TO: District of Columbia Zoning Commission
FROM: Jennifer Steingasser, ^{JLS} Deputy Director- Development Review & Historic Preservation
DATE: November 21, 2014
SUBJECT: Final Report – ZC 13-12 – Consolidated and Preliminary PUD at 1333 M Street, SE, with Associated Map Amendment

Figure 1. Consolidated and Preliminary PUD Site Plan

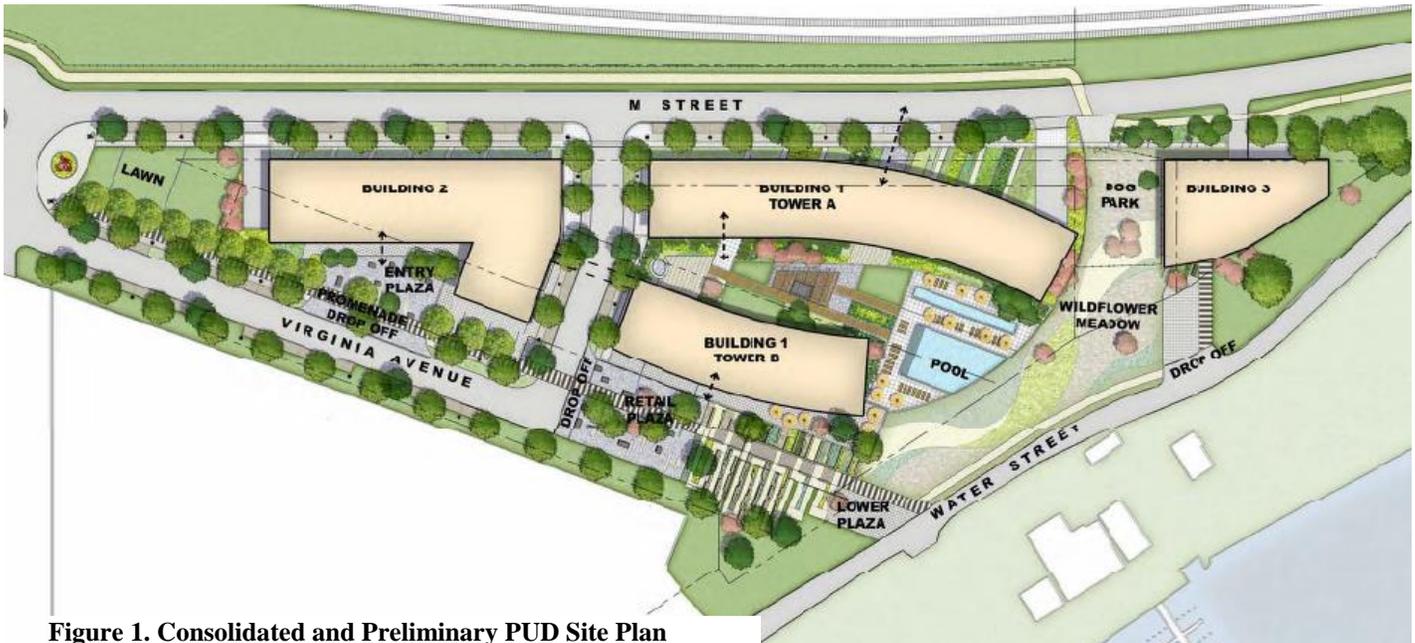
Similar to the Consolidated PUD, the Preliminary PUD requires relief from loading and roof structure height regulations but otherwise complies with the requirements of a PUD with related C-3-C zoning. Attachment 1's Tables 7, 8 and 9, provide a detailed zoning analysis focused on the Preliminary PUD's Building 1 Tower B, Building 2 and Building 3.

- § 2201, to provide thirty-foot long, rather than a fifty-five foot long, loading berths in Buildings 2 and 3.
- § 2201 to omit a 20 foot service delivery space while increasing the loading platform from 100 sf to 200 sf.
- §§411.2 and 770.6(b) to provide varying height roof structures for Building 2 and Building 1, Tower B.

The applicant will need to provide additional information by the public hearing about why the relief is appropriate. However, at the time this report was completed neither DDOT nor OP had concerns with this requested relief.

Figure 4. Consolidated PUD - as of 10-20-13

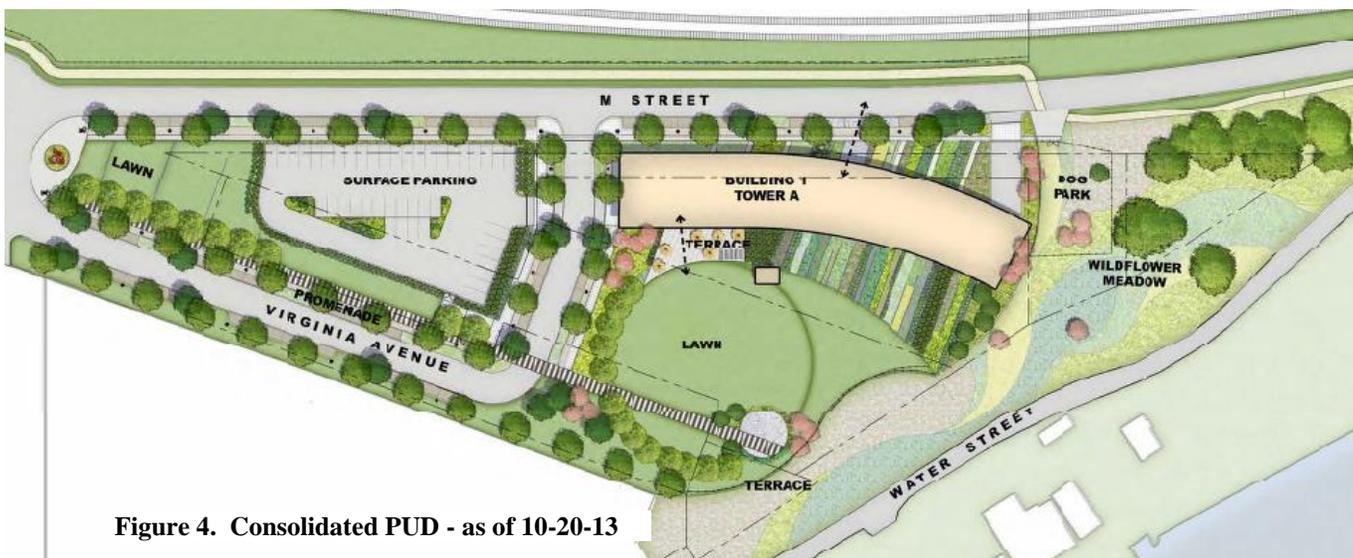
With the exception of the length of the proposed loading berth, the varying height of the roof structure, and its setback, the consolidated PUD complies with the requirements of a PUD with related C-3-C zoning.

The applicant has provided the following explanation of why granting three feet of setback relief would be appropriate for the center section of the roof structure: *The parapet is 3’-0” h, therefore, due to the 45 degree site line from the edge of the parapet the height of the penthouse can be 3’-0” taller than the distance.* Although the proposed dimensions do not seem to have a negative impact on the building or its surroundings, it is still necessary to discuss why such relief is needed.

The applicant has refined the design since setdown by proposing less saturated masonry colors on the north side, increasing the transparency of the ground floor, adding windows and bays on the east and west walls to transition between the water-side and land-side side building facades, and has lightened up the overall feel of the north side by including light-colored horizontal elements similar to some on the south side.

The roof structure has also been simplified to allow for more views through it from the north.
